Access Compliance Report

Public Rights-of-Way

(Curb Ramps)

Intersection ID: 30402	Main Street: WOODLAWN_RD	Cross Street: PARK_RD_SHOPPING_CENTER_DR	Location: NW
ADA ID: D6D9EF1CD617	Ramp Type: Perp	Initial Pass/Fail: Fail	Overall Compliance: No
Severity Score: 37.5			
Codes/Mitigation Info/Possible Solution		Field Measurements/Component Compliance

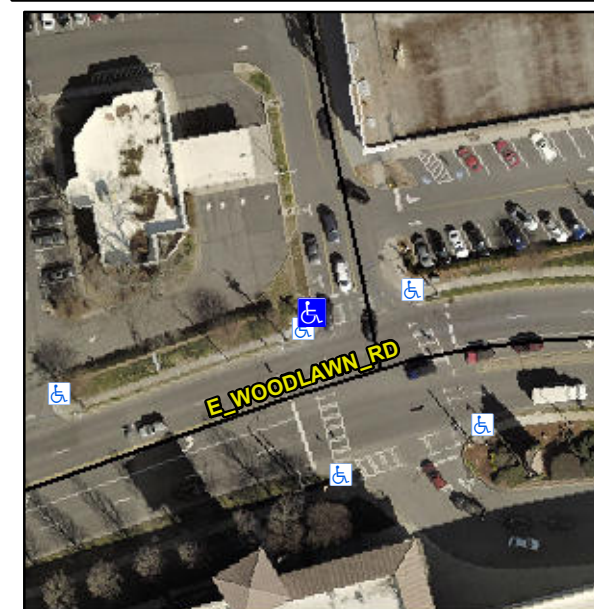
Not Found, R304.2.2, R304.5.3

Compliance	Description	Data	Compliance	Description	Data
N/A	Ramp Length (in)	24.0	No	Ramp Slope (%)	9.0
Yes	Ramp Width (in)	48.0	No	Ramp XSlope (%)	7.9
N/A	Flare Type LT	N/A	N/A	Flare Type RT	N/A
N/A	Flare Slope LT (%)	N/A	N/A	Flare Slope RT (%)	N/A
N/A	Flare Traversable LT?	N/A	N/A	Flare Traversable RT?	N/A
N/A	Landing Length (in)	N/A	N/A	DWS Provided?	N/A
N/A	Landing Width (in)	N/A	N/A	DWS Contrast?	N/A
N/A	Landing Slope (%)	N/A	N/A	DWS Length (in)	N/A
N/A	Landing X Slope (%)	N/A	N/A	DWS Full Width?	N/A
N/A	Landing Curb? (Y/N)	N/A	N/A	DWS Offset (in)	N/A
N/A	Shared Landing?	N/A			
N/A	Gutter Ponding?	N/A	N/A	Gutter Slope (%)	N/A
N/A	Gutter Lip Ht (in)	N/A	N/A	Gutter X Slope (%)	N/A
N/A	Painted X Walk1?	Yes	N/A	Painted X Walk2?	N/A
	X Walk 1 Direction	To E		X Walk 2 Direction	N/A
N/A	X Walk 1 Width (in)	103.0	N/A	X Walk 2 Width (in)	N/A
	X Walk 1 Slope (%)	1.3		X Walk 2 Slope (%)	N/A
	X Walk 1 X Slope (%)	1.1		X Walk 2 X Slope (%)	N/A

N/A	Ramp inside XWalk1?	Yes	N/A	Ramp inside XWalk2?	N/A
	Road Slope (%)	N/A	N/A	Clear Space?	N/A
	Road X Slope (%)	N/A	N/A	Clear Space to XWalk (in)	N/A
N/A	Any Obstructions?	N/A	N/A	Storm Grate/Utility Hazard?	N/A
	Obstruction Type			Storm Grate/Utility Type	
		N/A			N/A
		Yes		Surface Condition? (G/P)	Good

Remove & Replace Entire Ramp.
